Z-27
(2013)
REVISED SITE
PLAN

PETITION NO: Z-27

ZONING COMMENTS:

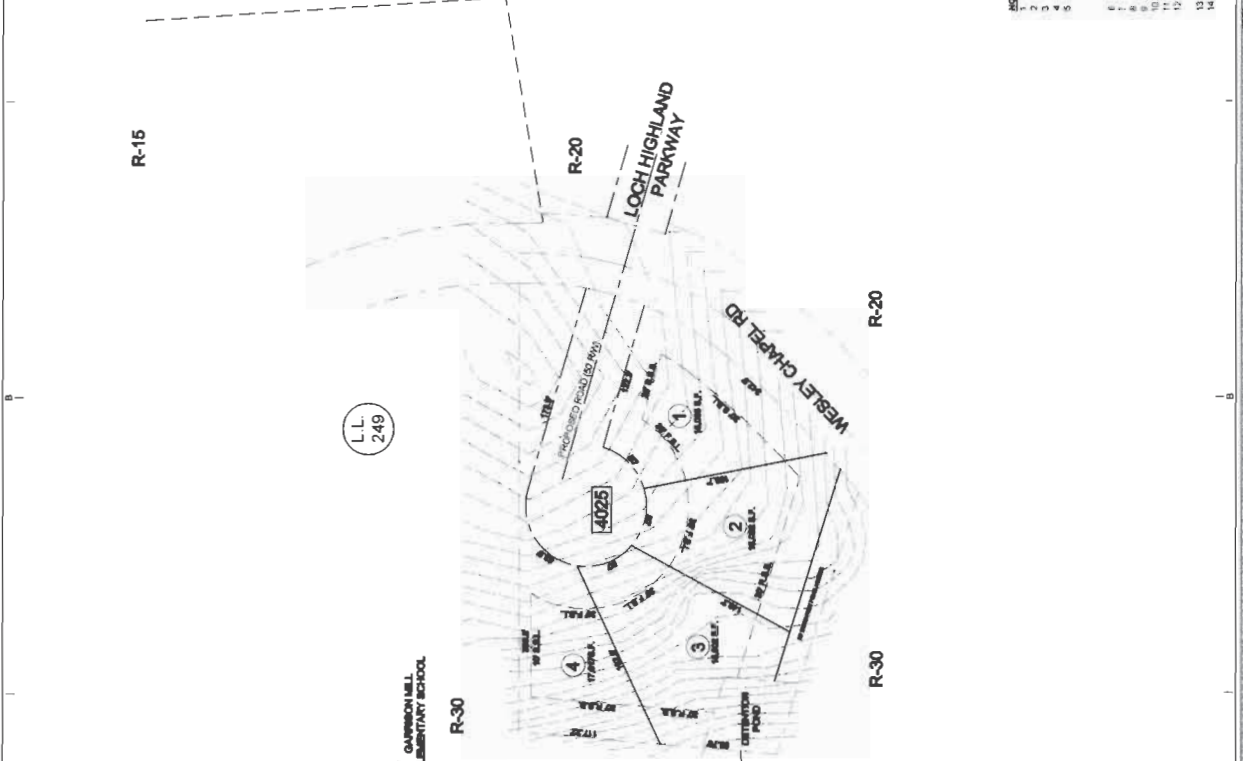
- No Stormwater controls shown _____
- Copy of survey is not current – Additional comments may be forthcoming when current site conditions are exposed.
- No site improvements showing on exhibit.

1. This parcel is located to the west of Wesley Chapel Road and is bounded by the Robert Hicks Farm to the south and Garrison Elementary School to the north and west. Approximately a third of the site drains to the south along the right-of-way of Wesley Chapel Road. The remainder of the site drains to the southeast through the Robert Hicks Farm property. Stormwater conveyance through this parcel is limited. There is an existing 18-inch CMP culvert located at the property line that flows under an existing barn/shed. This pipe discharges into an existing farm pond with limited spillway capacity. Detailed hydraulic analysis will be required at Plan Review to verify no adverse impact to these offsite systems.

2. While the location of the detention pond is at the low point of the site, the proposed access from the right-of-way is along the southern boundary of the site and will require total clearing for maintenance access. This will eliminate any buffer for the adjacent property owner.

3. A pre- and post-development sediment survey will be required for the downstream farm pond.
